**ADDENDUM  
NO. 3**

**February 21, 2025**

**TRI-COUNTY SCHOOL CORPORATION – JR-SR HIGH SCHOOL  
ADDITION AND RENOVATIONS  
Wolcott, IN 47995**

**Addendum Three (AD.03)** to the drawings and specifications prepared by Gibraltar Design for **Tri-County Jr/Sr High School Additions and Renovations** for Tri-County School Corporation, Wolcott, Indiana.

**DRAWING**  
**S A-104**

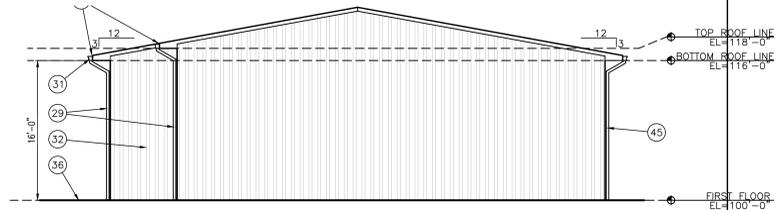
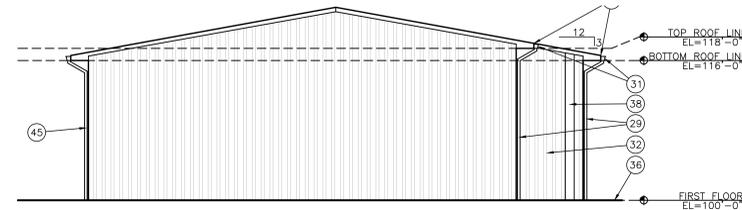
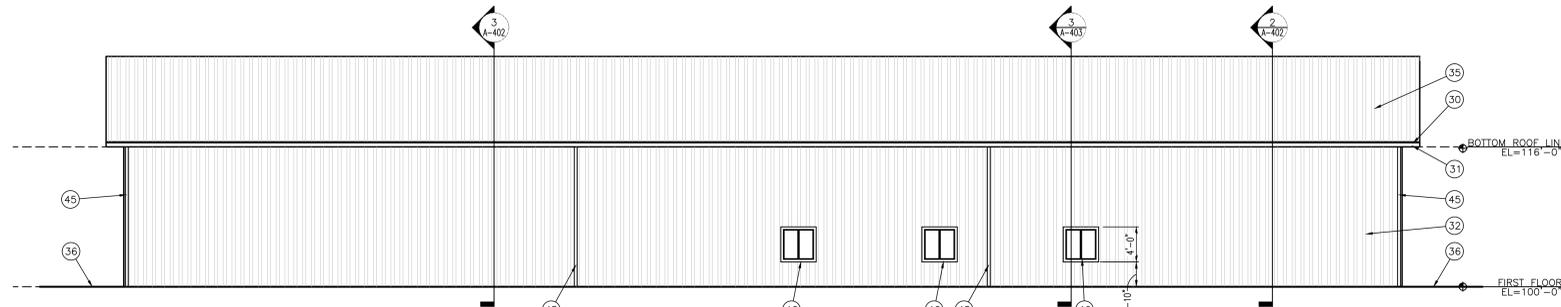
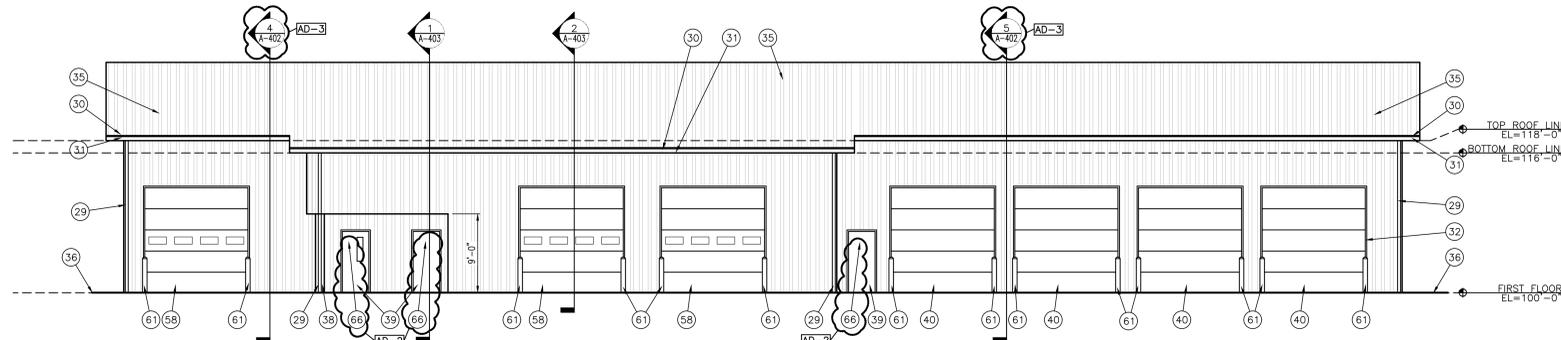
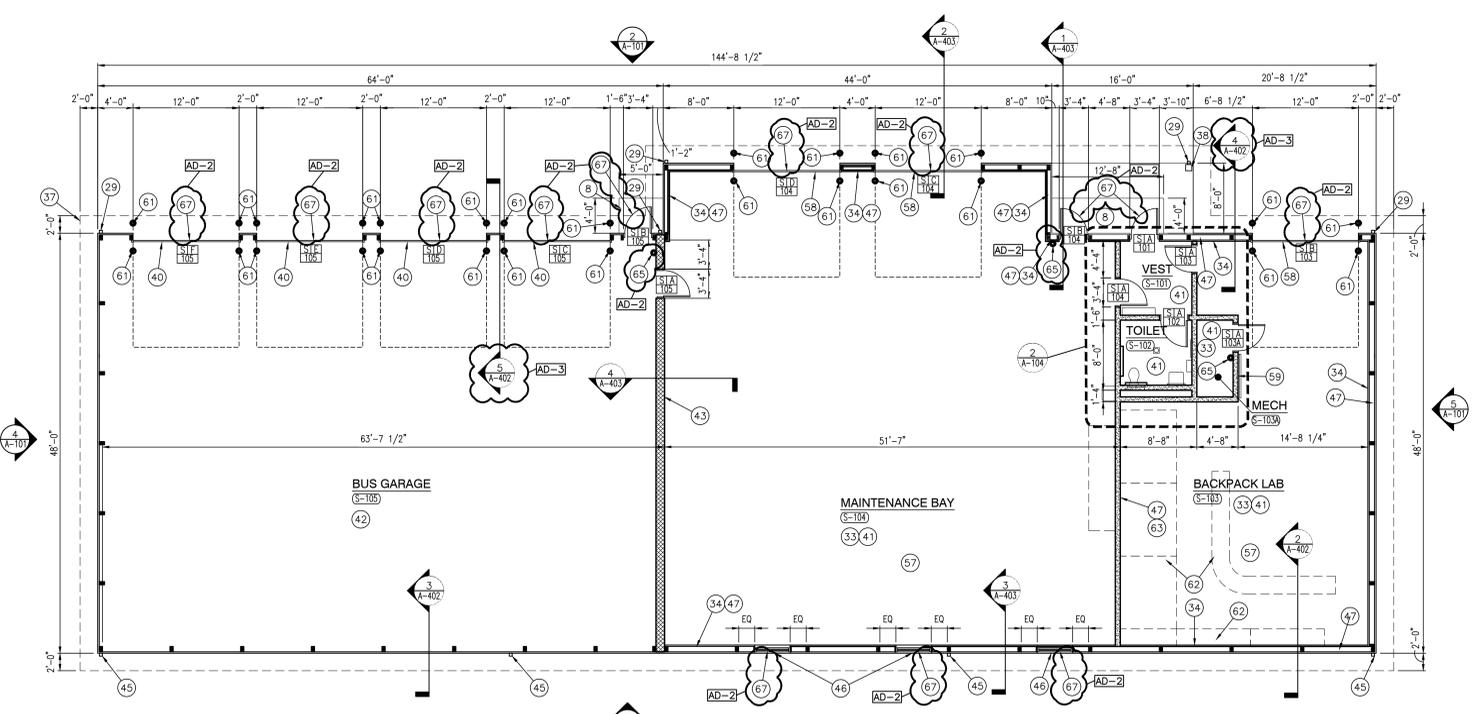
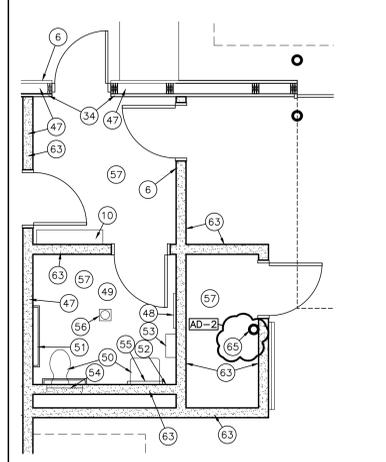
1. **Sheet AD101-103 (Drawings not attached)**
  - A. Remove notes 15, 16, 18, and 27 from the scope of work.
2. **Sheet A-104**
  - A. Add additional section cuts to floor plan and North Elevation.
3. **Sheet A-201**
  - A. Add roof type "C" and replace roof type "A" to "C" for select locations on roof plan.
4. **Sheet A-401 (Drawing not attached)**
  - A. Add note on section 2, 3, and 4 "New roof membrane, refer to roof plan."
5. **Sheet A-402**
  - A. Add sections 4 and 5 and reorganize sheet.
6. **Sheet A-403**
  - A. Revise section 1 to increase the roof eave height to match elevations.
7. **Sheet A-801-803 (Drawings not attached)**
  - A. Remove notes 8 and 9 from the scope of work.
8. **Sheet E-701 (Drawing not attached)**
  - A. Delete (Alternate Bid) from Plan Note 3. This work is Base Bid.
